Minute No. 461
Report – Standing Policy Committee on Property and Development, Heritage and Downtown Development – July 5, 2016

Item No. 8 Amendment to the Bishop Grandin Crossing Area Master Plan (River Heights – Fort Garry Ward) File SPA 3/2016

Title: SPA 3/2016, Amendment to the Bishop Grandin Crossing Area Master Plan

Issue: The property owner is proposing to make minor amendments to the Area Master Plan approved by Council in 2014 to reflect a realignment of the road network and to accommodate all drainage requirements on-site.

Figure 1: Bishop Grandin Crossing Site Location and Context, showing proposed amendments

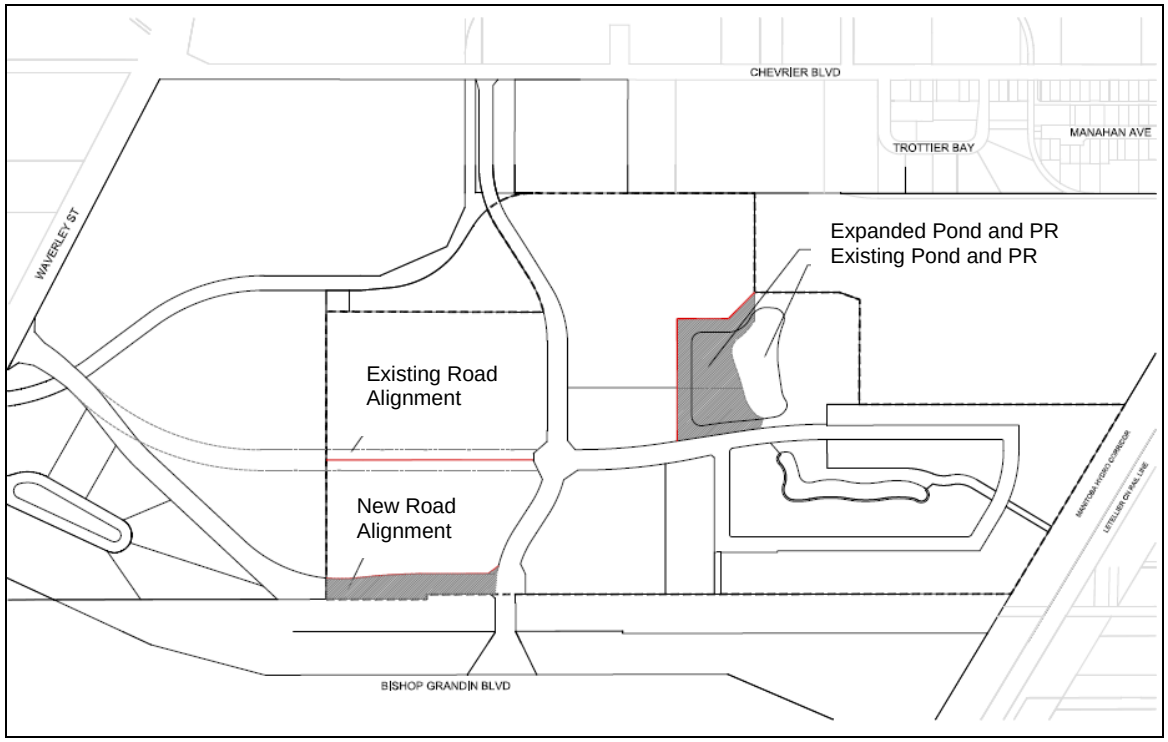
The applicant has indicated that an intent of the application is to request a change to the alignment of the Scurfield Boulevard Extension. Hopewell would like to use the existing, right-of-way (ROW), and no longer requires the realignment of the ROW further north that was endorsed by Council as part of the Area Master Plan under SP 1/2014 (see Figure 1 above). In addition, Hopewell would like to 'widen' the proposed stormwater retention pond to the west, north of Ballantrae Drive (PR "A"). The pond has now been sized accordingly to accommodate on-site storage requirements.

The proposed change to the roadway alignment comes about due to an issue experienced in acquiring land for the westerly extension of Ballantrae Drive to Waverley Boulevard. The original Area Master Plan contemplated a four-legged intersection at Newmarket and Ballantrae, however, lands west of the Sugar Beets site are owned by Manitoba Hydro and contain an active storage yard. Hydro was not willing, at this time, to release these lands for redevelopment, exchange and the roadway extension. As a result, Hopewell is proposing to revert to the option of the existing Scurfield right-of-way which is legally available, but not currently opened or constructed as a street along the south boundary of the MRS.

In the future, the westerly extension of Ballantrae at Newmarket is proposed to be a private street serving adjacent development. For the time being, the intersection would function as T-intersection. A new roundabout is proposed at the intersection of Scurfield and Newmarket with size and actual location to be determined as part of the detailed engineering work.

The proposed change to the retention pond and associated park lands north of Ballantrae Drive is necessitated by the need to accommodate all drainage requirements on-site rather than acquiring additional lands outside the site to the west for a third retention pond. Expansion of the northerly pond was viewed as the best option to consolidate land drainage facilities and

maximize infrastructure efficiencies while at the same time enhancing open space, pathways and recreational uses in the vicinity. The required expansion of the pond reduces the developable area of the site by about 5 acres and extends into land formerly designated as industrial and commercial mixed use. The additional impoundment lands will be dedicated to the City as Public Reserve through the subdivision process (under separate application). Pathways will now extend around the full expanse of the pond.
